- Subject** ▶ Change of Conical Compression Spring 18-29
- For Models** ▶ 6791D, 6793D
- Country** ▶ All countries
- Description** ▶ The spring of the subject has been changed as illustrated below.

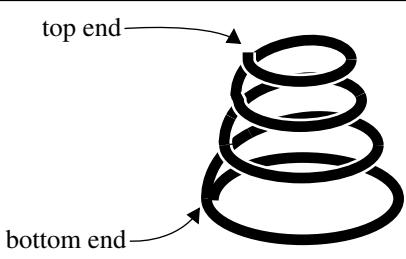
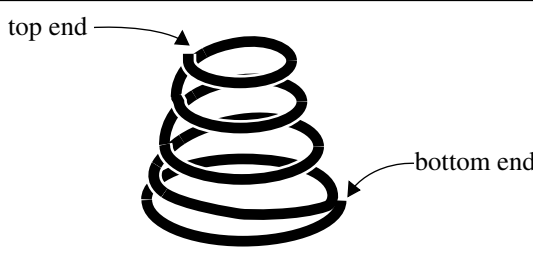
▶ Current	▶ New
Conical Compression Spring 18-29		
Part No.	231945-3	231997-4
Number of coils	4 coils	4.5 coils
Position of top end and bottom end	on the same side	on the opposite sides

Item No.	Current part		Q'ty	I/C	New part		Q'ty	Note
6791DW; 025 6793D ; 025	Conical Compression Spring 18-29 231945-3		1	←	Conical Compression Spring 18-29 231997-4		1

- 1) Interchangeability mark ; ← means that the new part is substituted for the current.
- 2) The current Conical Compression Spring can be used for the repair of Models 6792D and 6794D.

6791D : From serial No.514834E (May,1999)

6793D : From serial No.14771E (Apr.,1999)
